Isolation Resistance Measurement

March, 2018

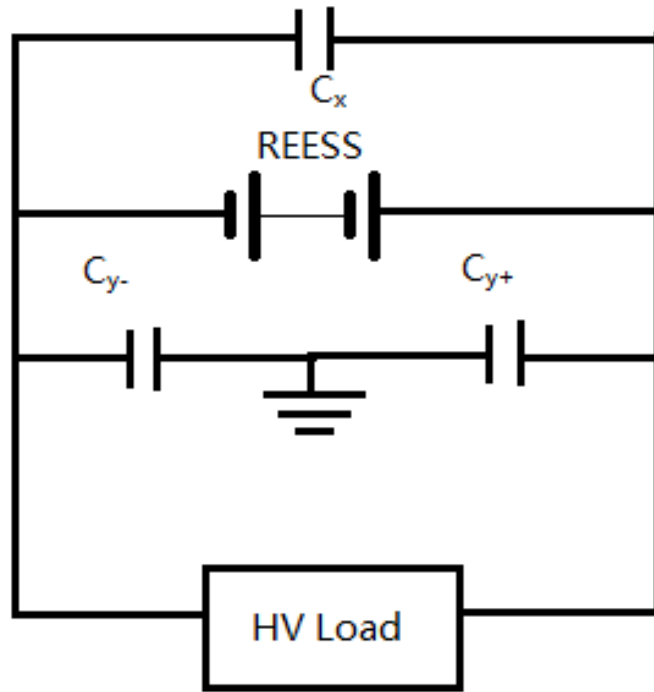
Recommendation:

Step3: if $V_1 \geq V_2$, insert R_0 as the picture. or if $V_1 < V_2$, insert R_0 between negative side and electrical chassis.

Step5:
$$R_i = \frac{1}{\left[\frac{1}{R_0 \left(\frac{U_2' - U_1'}{U_2 - U_1} \right)} - \frac{1}{r} \right]}$$

V_1 , V_2 , V_1' , V_2' are stable, that's benefit for accuracy measurement

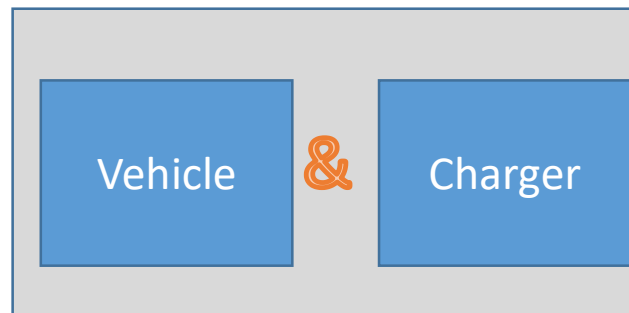
This safety requirement also need to be satisfied during conductive charging?
